Architect's Supplemental Instructions

Architect's ASI No: 019

Project:
Webster University
Interdisciplinary Science
Building

Description: ASI – 019 (RFI-193,RFI-208 & RFI-212)

1 DOMESTIC WATER SUPPLY RISER - LAB WASTE 372B, RESEARCH 374A, TISSUE CULTURE 374B AND COLD ROOM 378

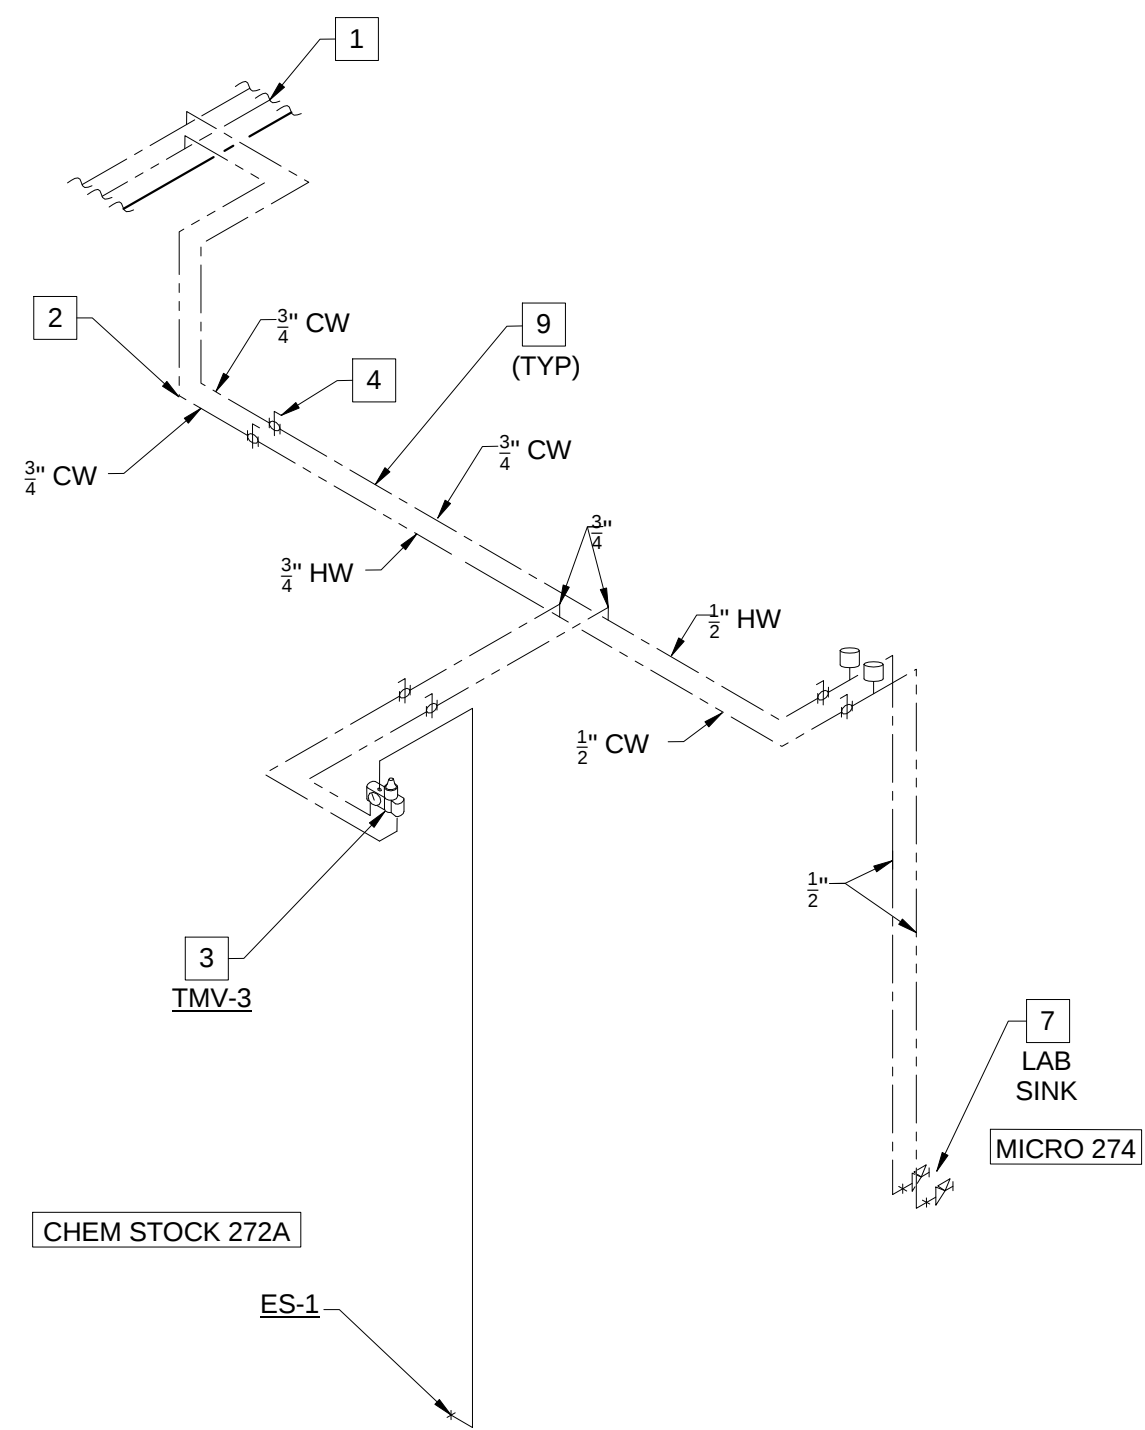
RFI-208,(P0103.A/P0407/P0409); request that attention be bought to the issue of length of the hot water run serving the island sink in Room 472 Chem Lab-General and Room 480 Chem Lab-Organic. The run of non-recirculated dead-end piping from the main to the sink would result in a long wait for hot water. As result water supplier to sinks were removed from the 4th Floor Level and moved to the 3rd Floor Level. In Room 478, some alignments were shorten, reducing the amount of 1-inch diameter piping by approximately 84 linear feet and in Room 472, alignments were shorten reducing amount of 1-inch diameter by 54 linear feet. Other pipe sizes were modified as well. Refer to drawing P0104.A and drawing P0409 for all associated modifications.

6 DOMESTIC WATER SERVICE ENTRANCE DETAIL
P0502 SCALE: N.T.S.

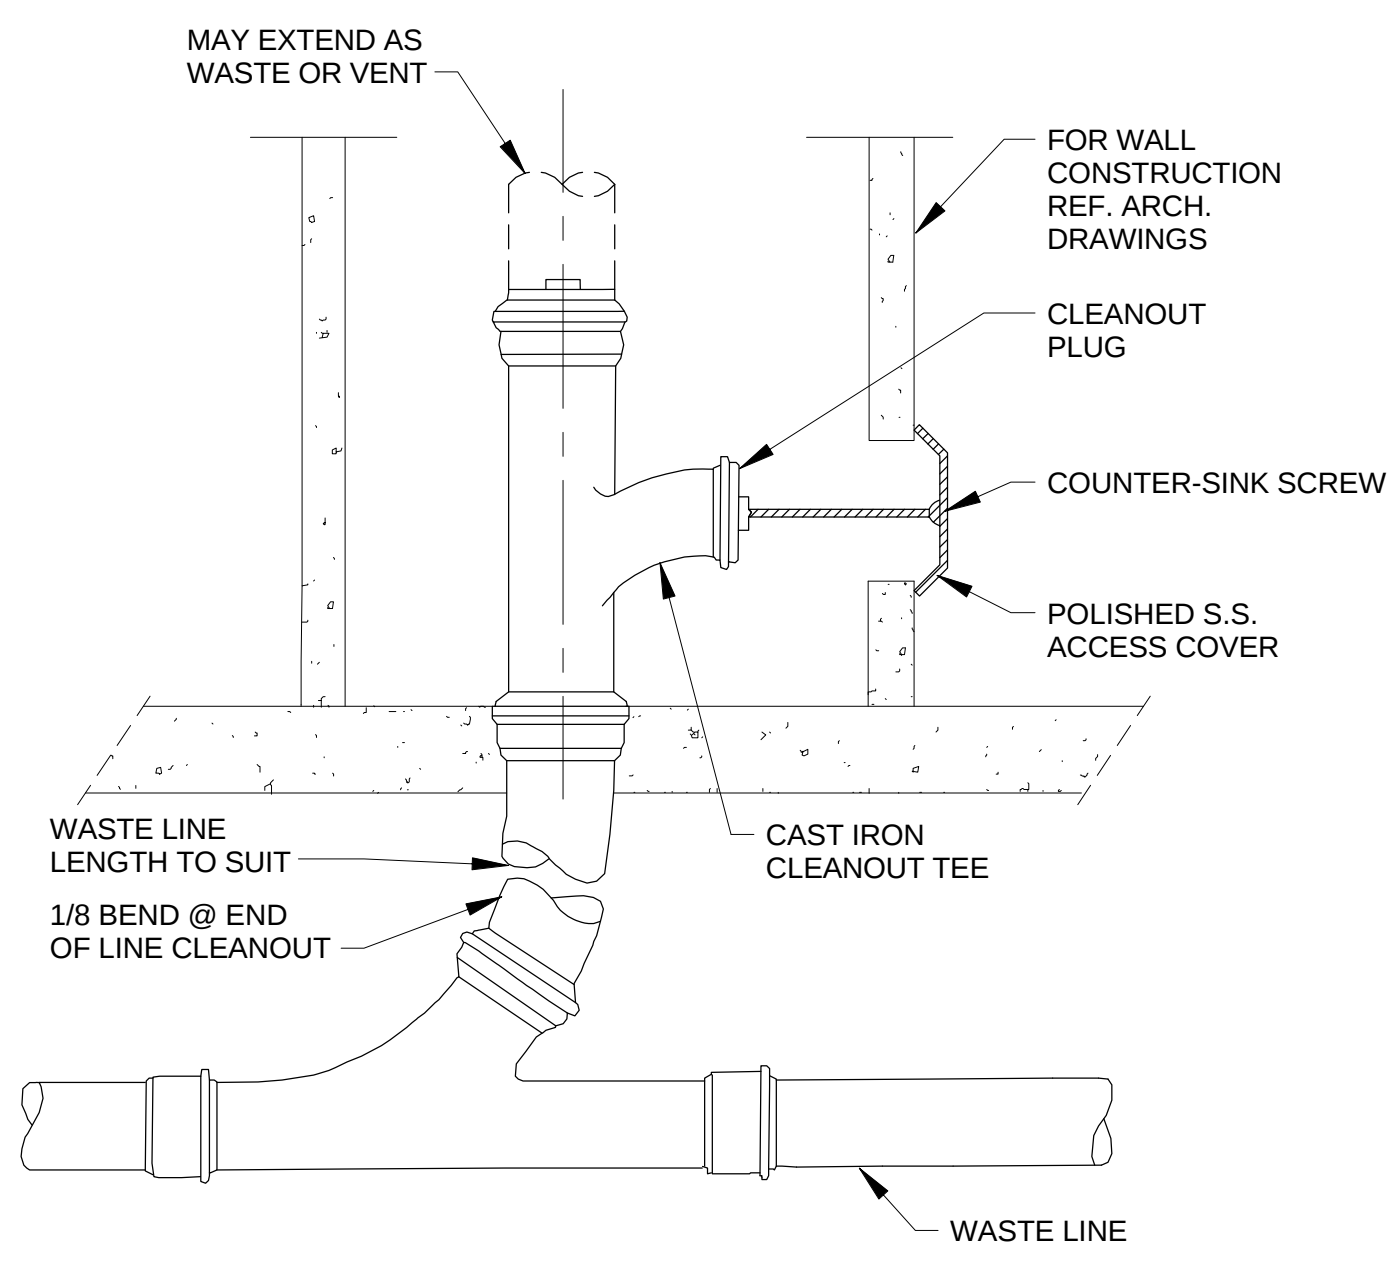
RFI-193, (P0502/P0601); request that additional information be provide for the purpose of adding a pressure reducing valve to the Domestic Water Backflow Preventer. Refer to drawing P0502, detail 6 for all modifications and drawing P0601, Schedule- Plumbing for specifications.
